United States Patent and Trademark Office

APPLICATION NO.	FILING DATE	FIRST NAMED INVENTOR	ATTORNEY DOCKET NO.	CONFIRMATION NO
10/813,545	03/29/2004	Dieter Schaffrath	A-3937	5313
23720 7	590 03/20/2006	,	EXAMINER	
WILLIAMS, MORGAN & AMERSON 10333 RICHMOND, SUITE 1100			COLILLA, DANIEL JAMES	
HOUSTON, T			ART UNIT	PAPER NUMBER
ŕ			2854	
		DATE MAILED: 03/20/2006

DETAILED ACTION

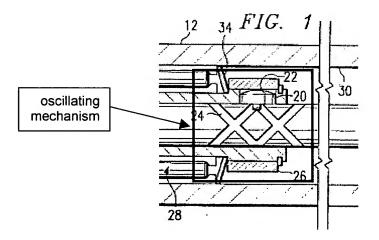
With respect to claim 1, Villarreal discloses the claimed oscillating roll assembly except for the at least one roll lock. Villarreal discloses an oscillating roll 12, a roll shaft 14 and a roll barrel rotatably and axially displaceably mounted on the roll shaft as shown in Figure 1 of Villarreal (Villarreal, col. 1, lines 33-44). Also disclosed is an oscillating mechanism (show below in the Figure taken from Figure 1 of Villarreal) for moving the roll barrel to and fro along the roll shaft 14.

With respect to claim 8, as shown in the above Figure, the oscillating mechanism is at least party integrated into the roll barrel.
